Application by Waterford County Council for Waste Licence Application
W0032-03 for Dungarvan Landfill, County Waterford

Replies to Request for further information in
accordance with Article 14(2)(b)(ii) of the Waste
Management Regulations

Dungarvan Landfill Waste Licence Application Article 14 Response

Drawing Number: **MDR0350/DG0607**
 Title: **LANDFILL GAS COLLECTION SYSTEM**

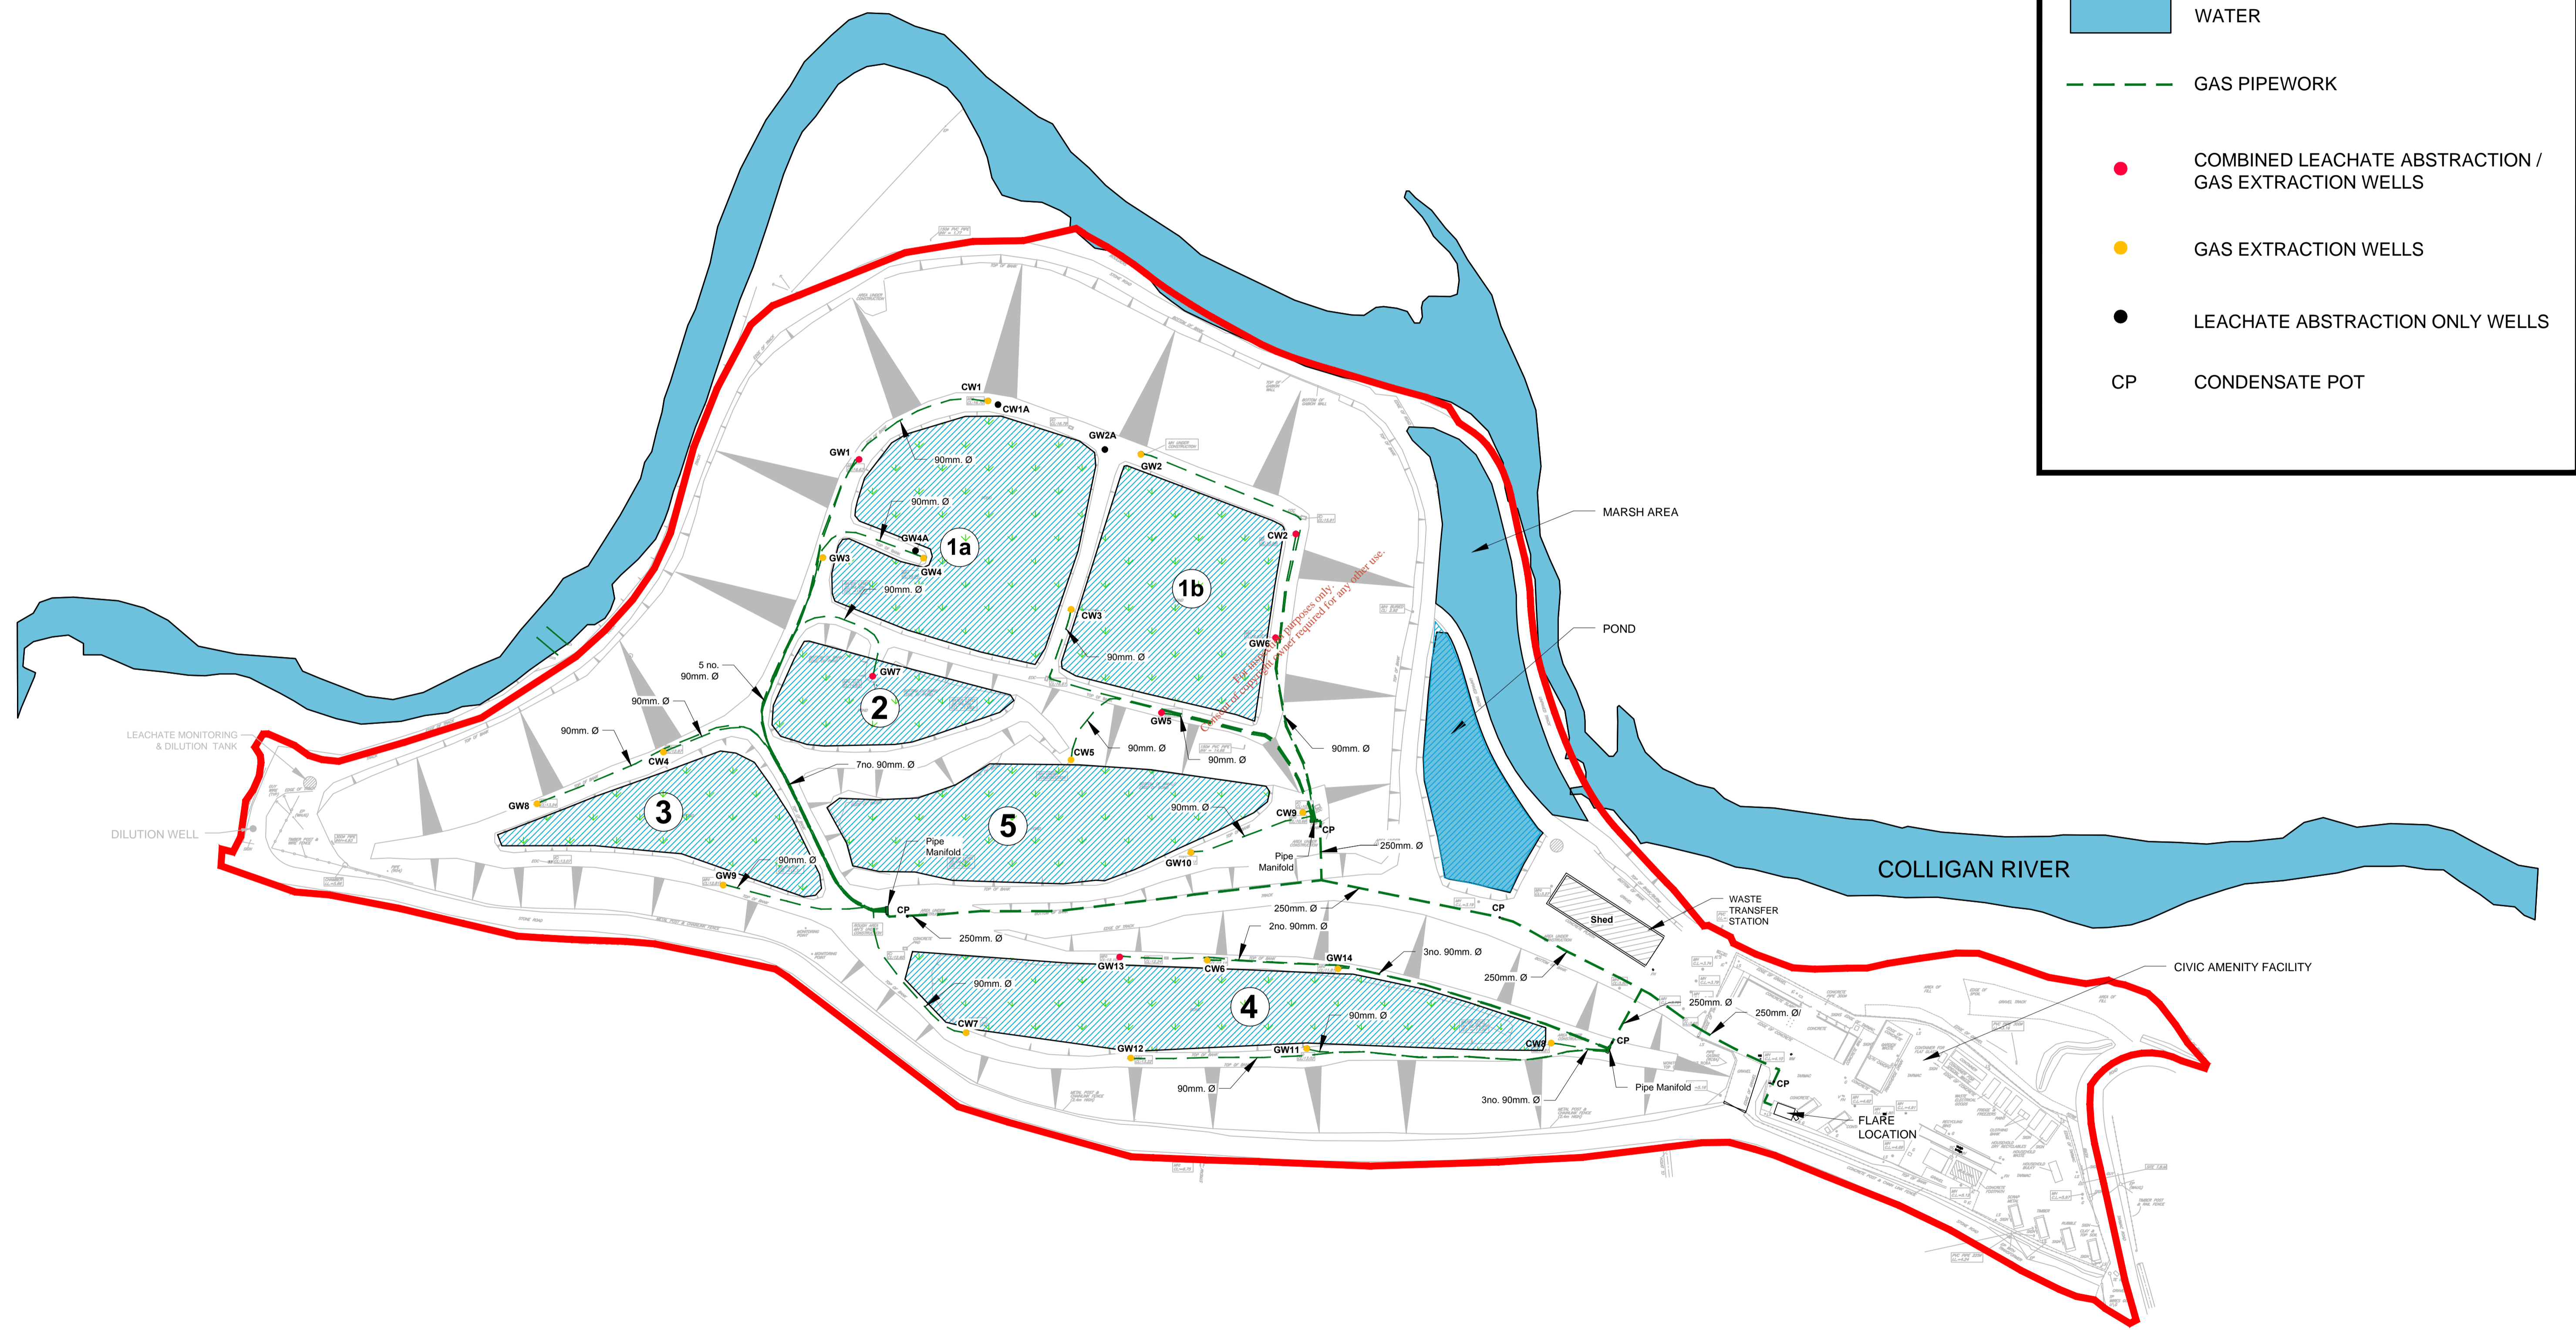
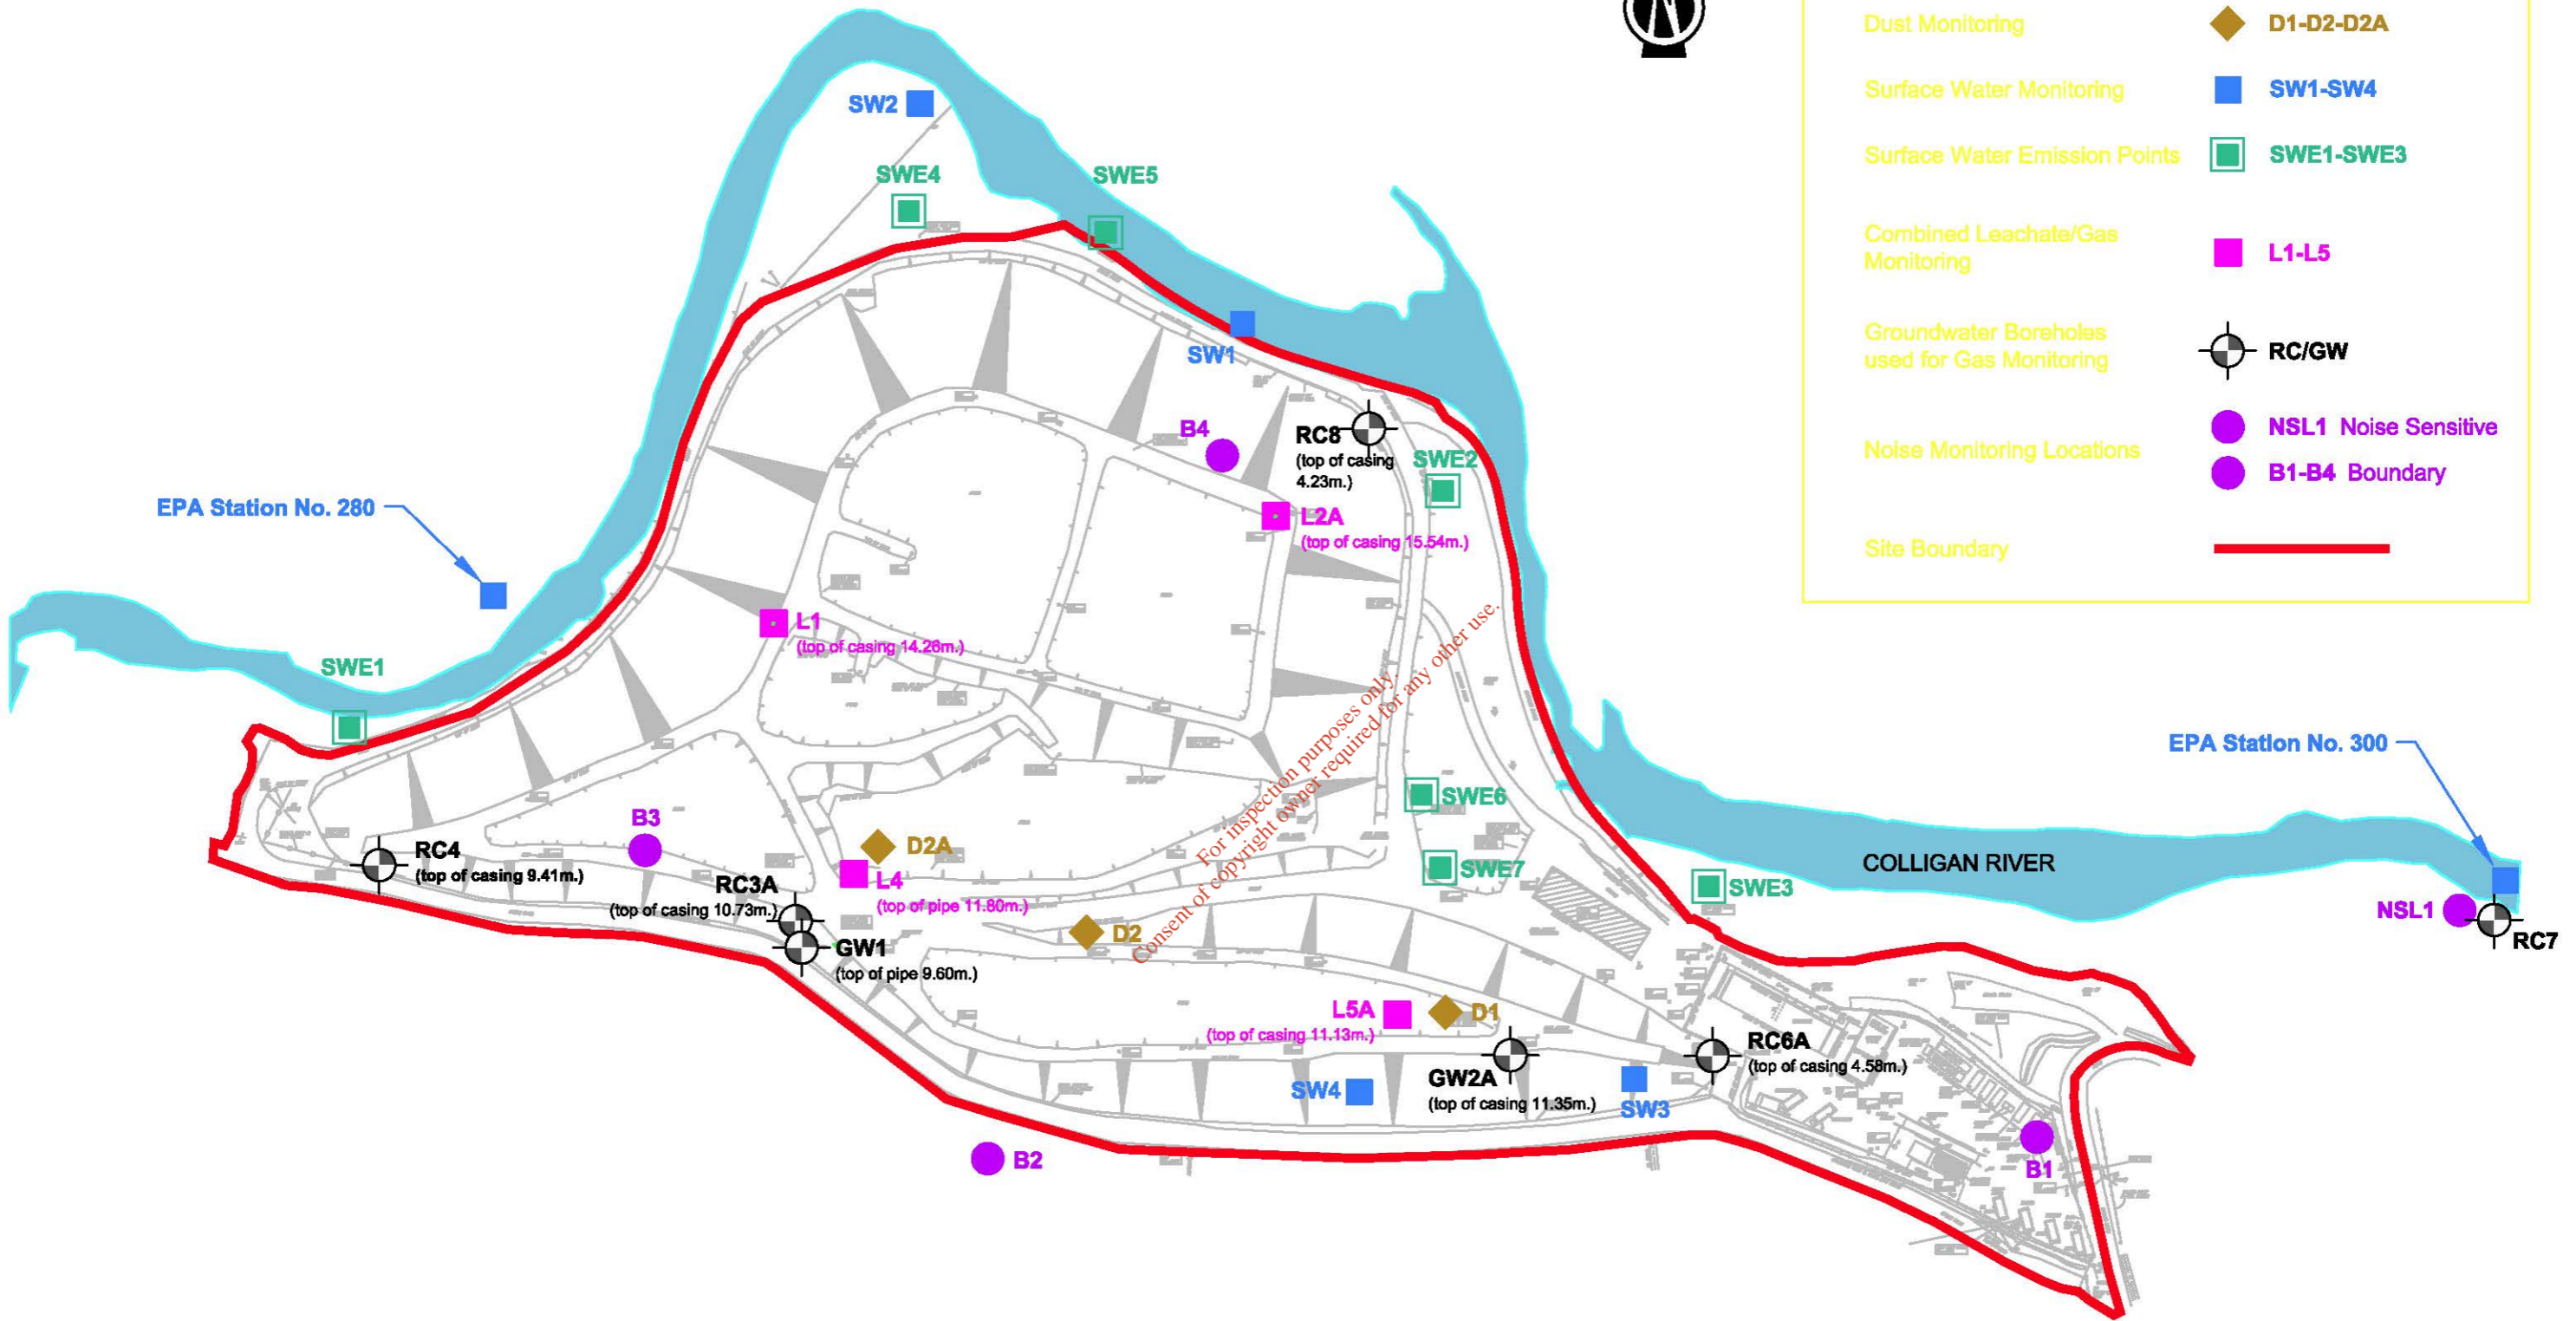
Provide a report on the status of all on-site landfill gas wells (abstraction and monitoring) and propose actions to be taken in relation to any wells that are not fit for purpose. Include a drawing showing the wells.

Please find Drawing No. DG0505 (Rev F02) attached showing all current monitoring locations together with their descriptions and symbols, together with DG0607 showing the gas collection system.

There are 23 no. gas abstraction boreholes, four no. combined leachate/gas monitoring boreholes (L1, L2A, L4, L5A), and seven groundwater boreholes used for gas monitoring (designated RC/GW on drawing).
